SUBMISSION OF REVISED PLANS APPLICATION

Application is hereby made for revising the plan(s) for: WATERSIDE PHASE III

**RE: Waterside – Phase III
 Amended Record Plans
 Bensalem Township, Bucks County, Pennsylvania
 ARNA Project No. 23000803**

The above documents have been revised based on comments received in email correspondences on July 24 and August 18, 2020 from the township engineer, Russell Benner, P.E.:

Drawing Title
FINAL MASTER SITE PLAN - PHASE III (RECORD PLAN)

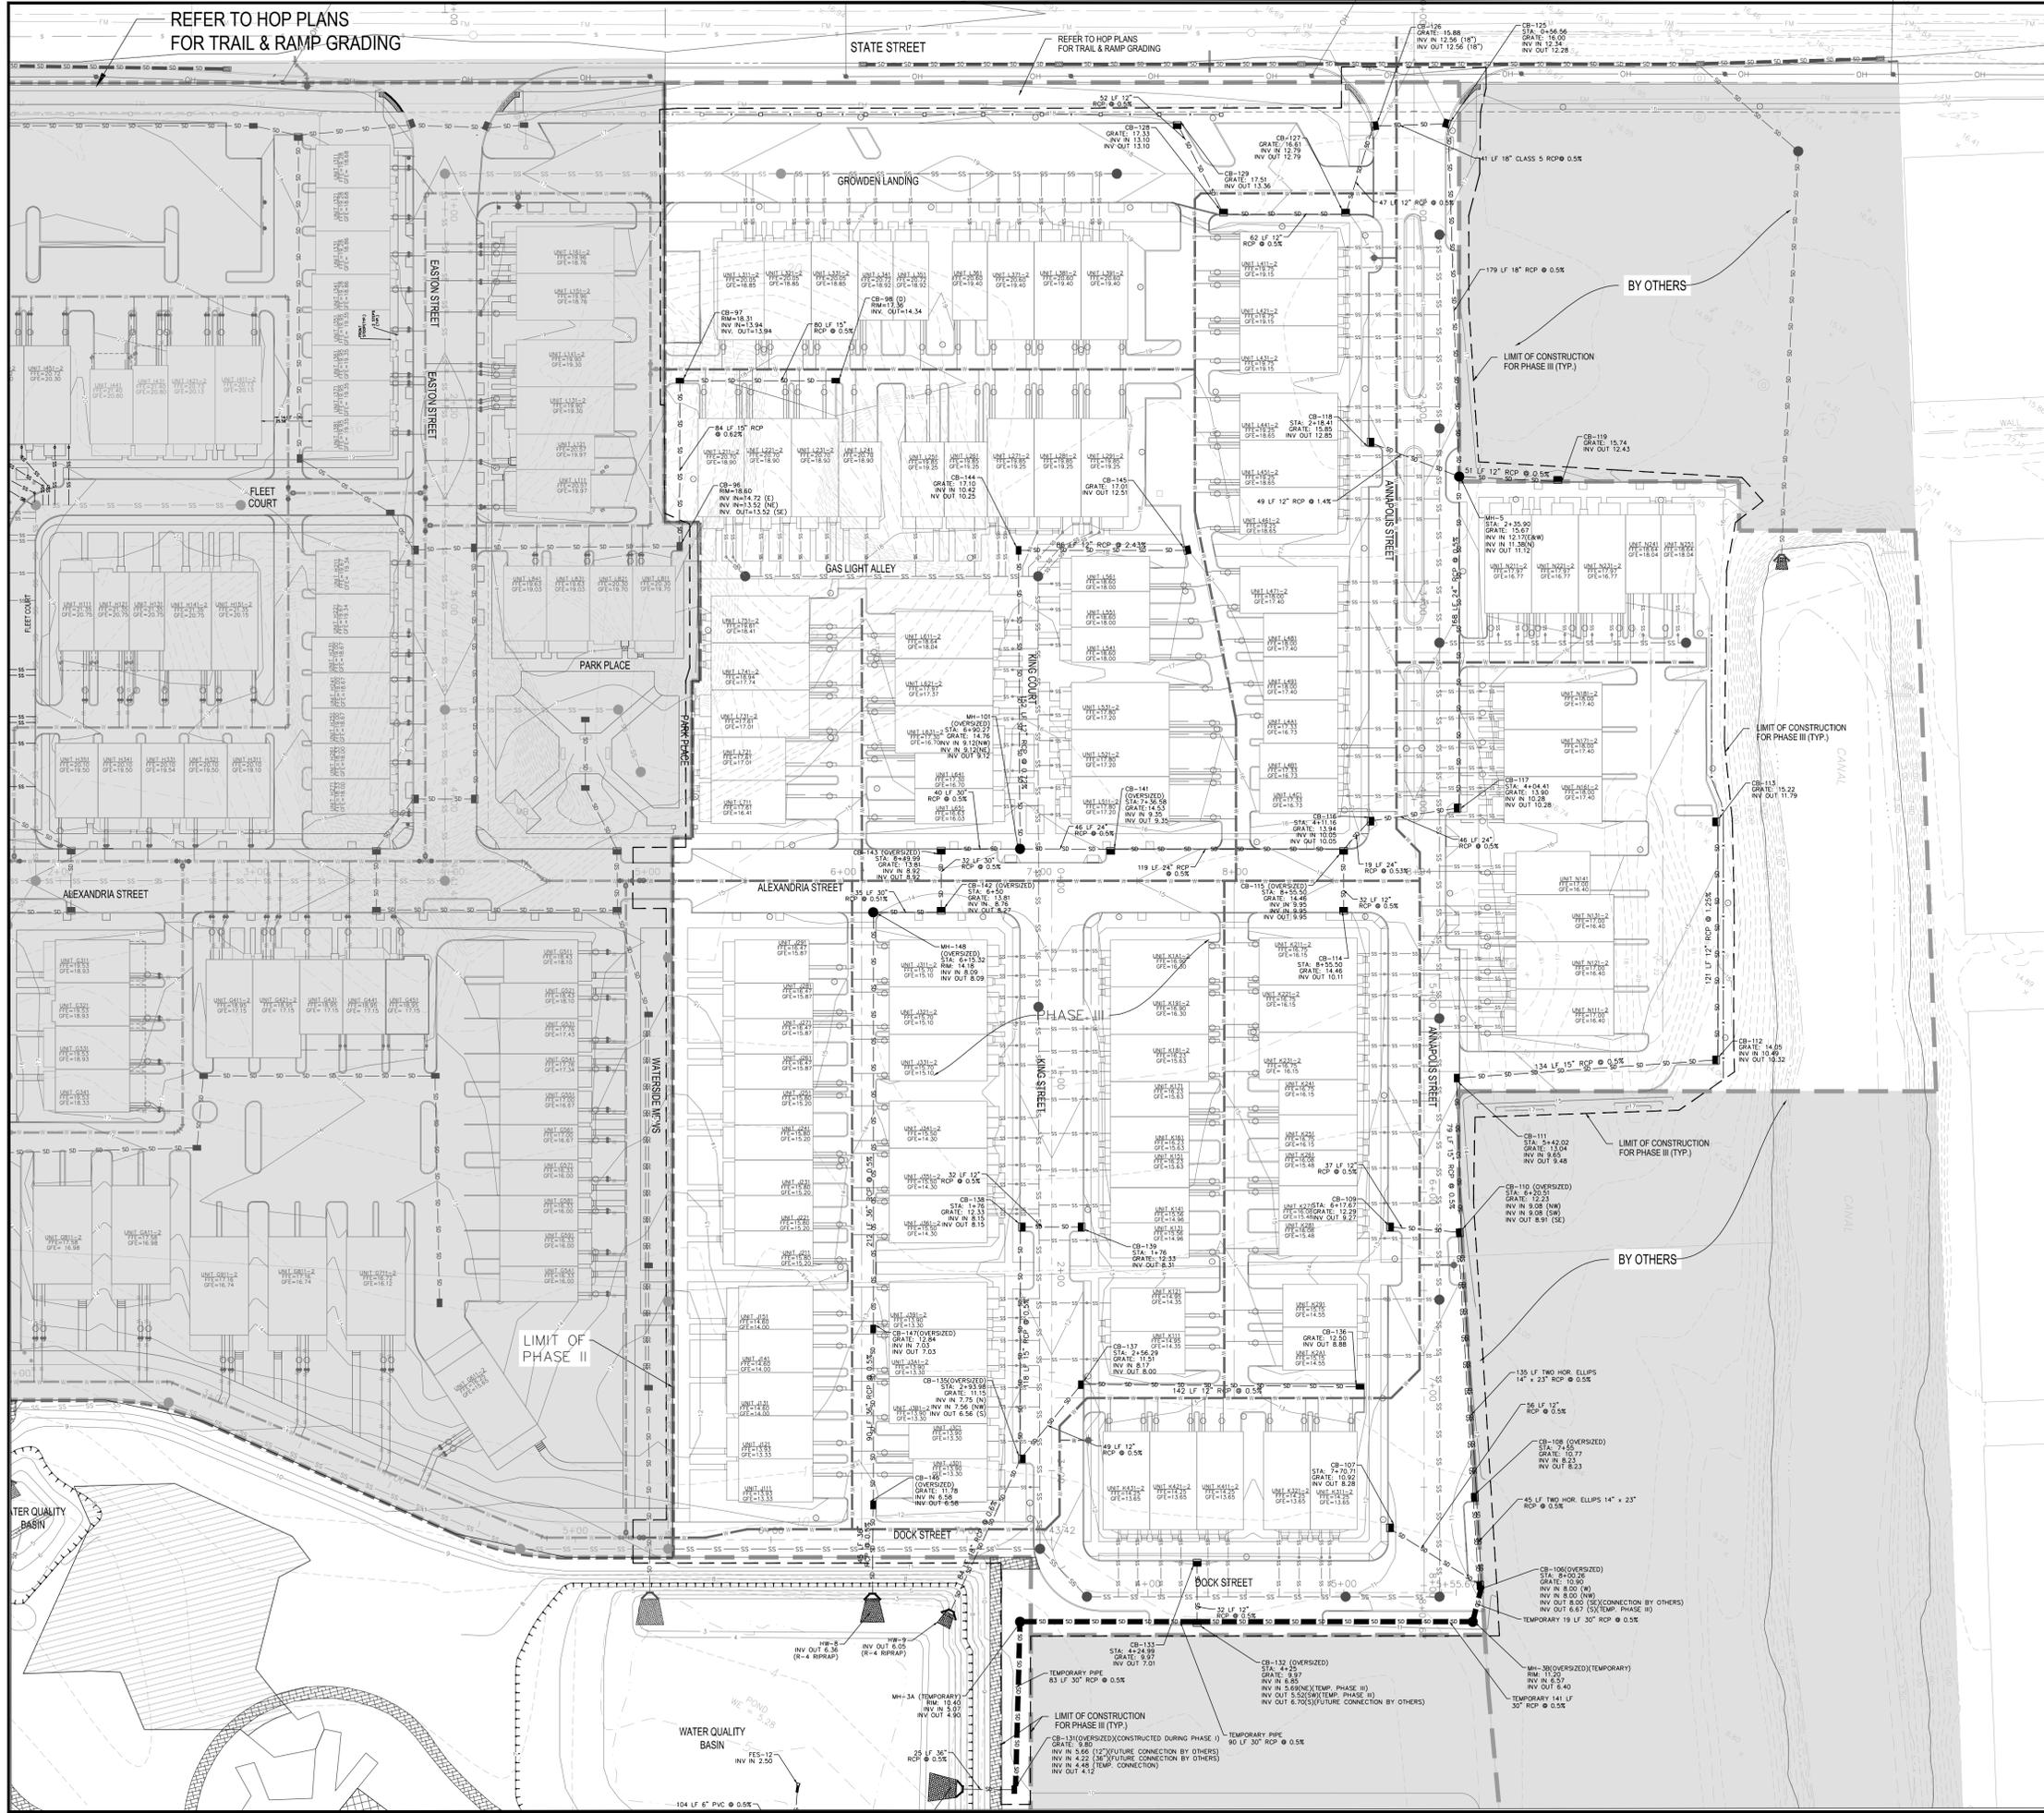
- 1. The provide zoning table must be revised to reference the correct ordinance sections.

- 2. Remove the duplicate Engineer's Certification signature block

Response: The zoning table has been revised to reference the correct ordinance sections per the comment.

Response: As per the comment, the duplicate Engineer's Certification signature block has been removed.

FINAL DRAINAGE PLAN - PHASE III

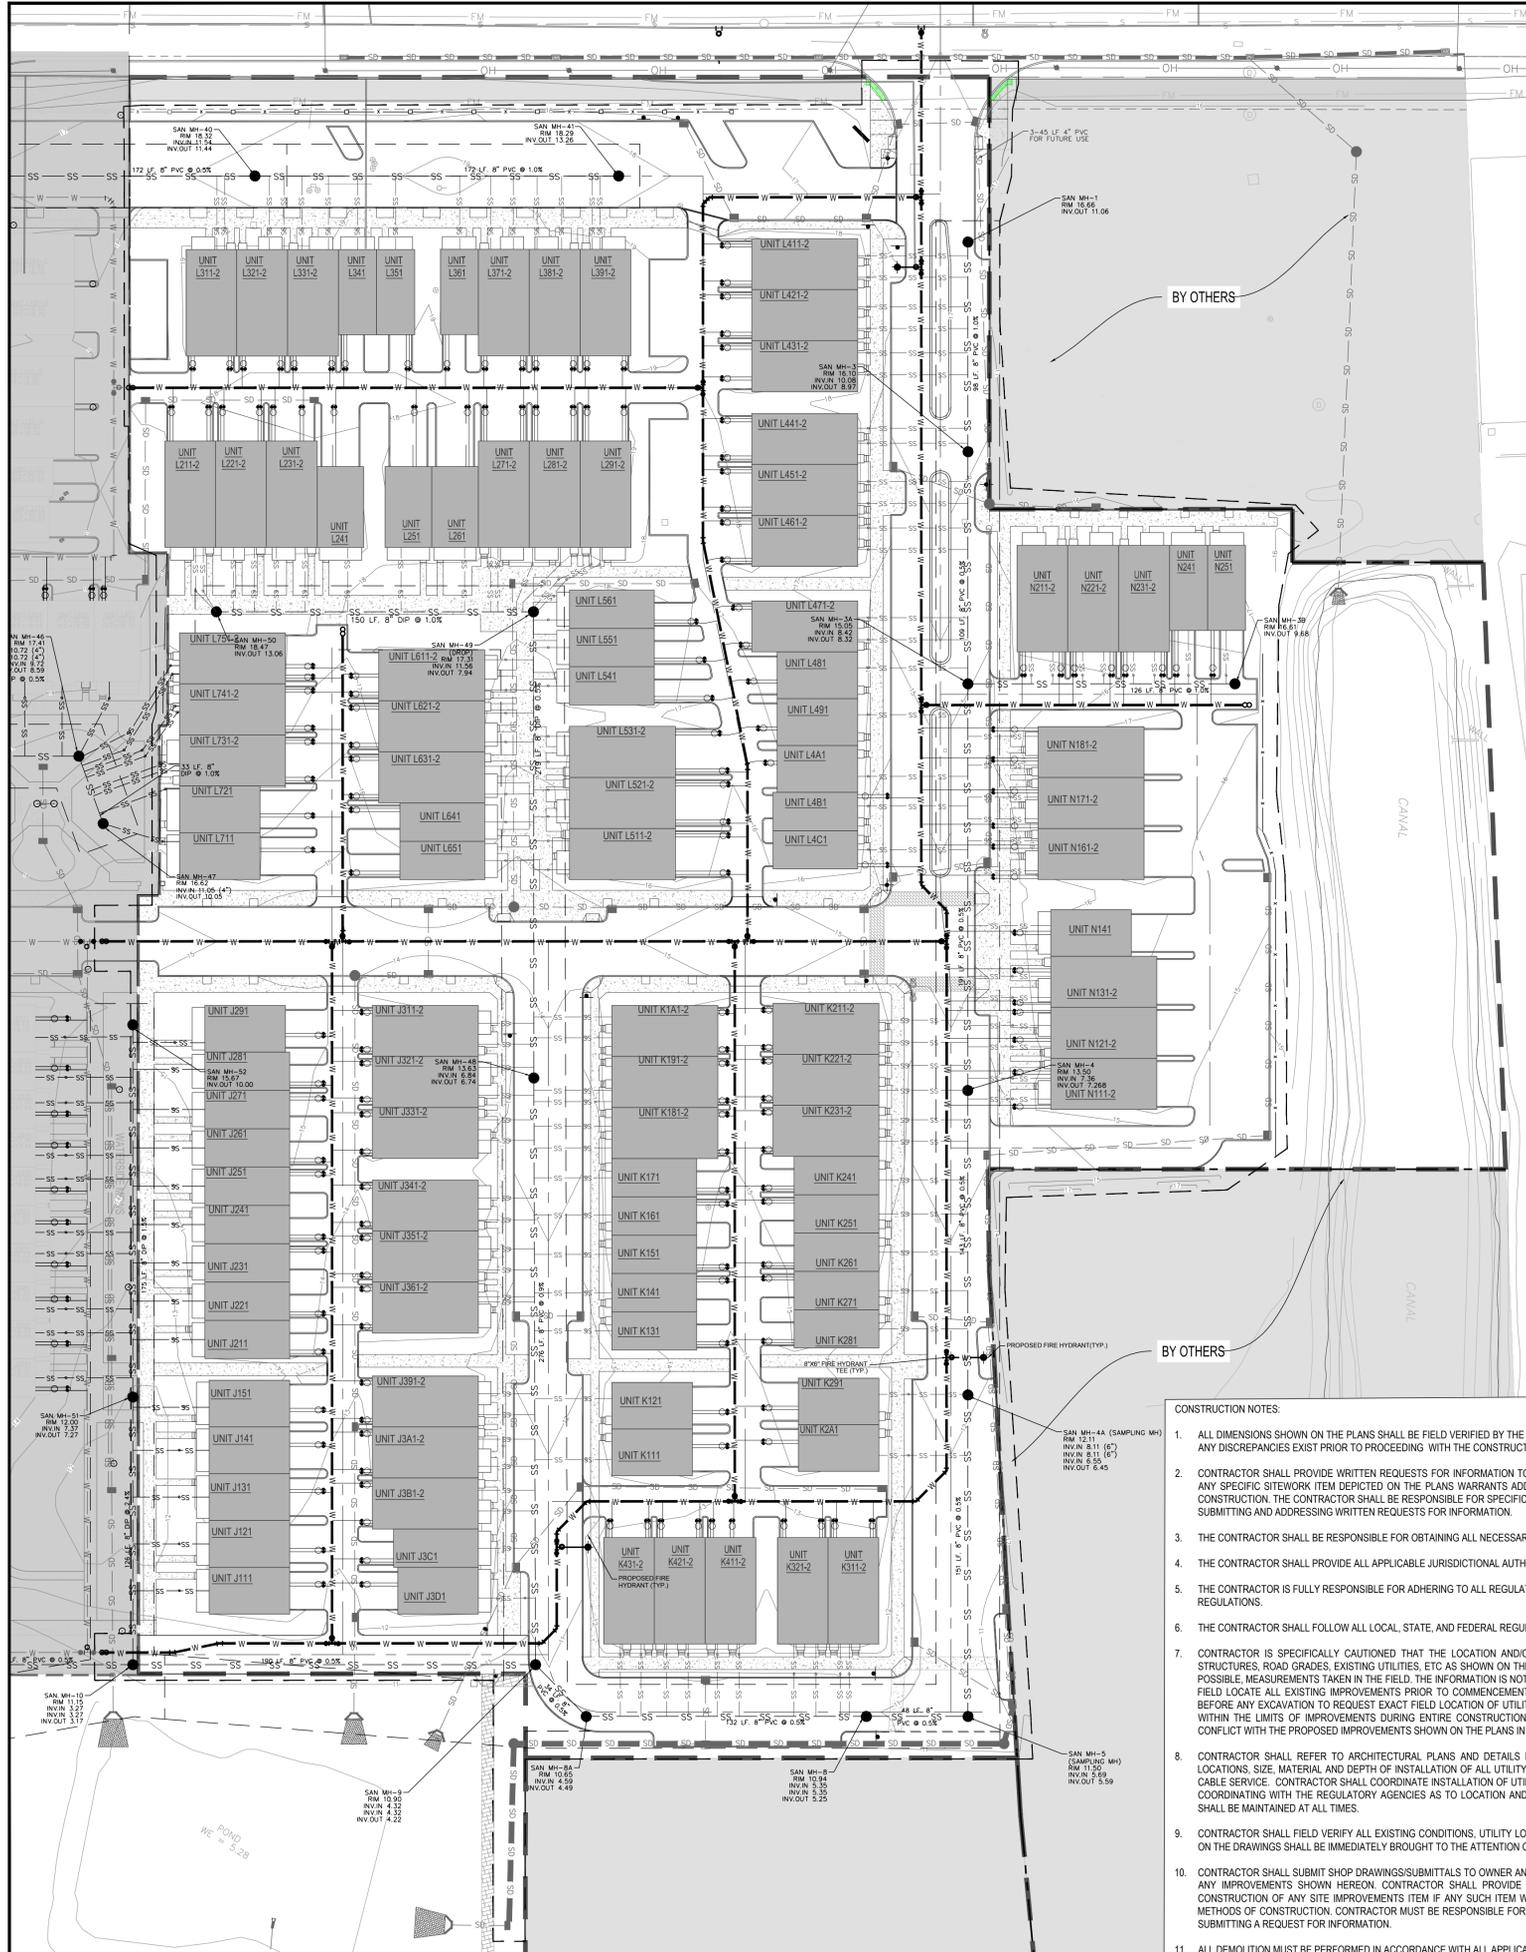
- 1. There are several items that were approved under the master plan that we would like to see revised, if possible.

- a. Minimum 2" drop in all inlets to the maximum extent feasible.

- b. Match pipe crown for differing pipe sizes to the maximum extent feasible.

- c. CM-137 & CM-111 are located within the intersection.

- 2. Missing labels/ features

- a. Show storm structure annotations for the phase 2 inlet adjacent to L211-2 on Gas

Light Alley to verify proper tie-in of the storm sewer from CB-97.

- b. MH-101 – missing invert annotations.

- c. CB-119 – show the INV IN pipe in plan view.

- 3. Drainage Concerns – The temporary storm sewer run appears to have issues including minimum cover, hydraulic capacity, etc.

Response: As per the comment, wherever feasible without impacting the cover over the pipe and the utility crossings, a drop of 2" has been proposed in inlets.

Response: As per the comment, wherever feasible without impacting the cover over the pipe and the utility crossings, crown match has been proposed in few inlets.

Response: As shown on the plan, these inlets are located at the entrance to the alleyway and not at the intersection of the street. Also, due to location of the property lines for future development by others, relocation of CM-111 is not feasible. Inlet CM-137 cannot be relocated due to the other utility conflicts (sanitary and water) in this area.

Response: As per the comment, the drainage plan has been revised.

Response: As per the comment, the drainage plan has been revised.

Response: As per the comment, the drainage plan has been revised.

Response: The temporary storm sewer system has been revised per the storm sewer calculations (included with this submission) per the comment.
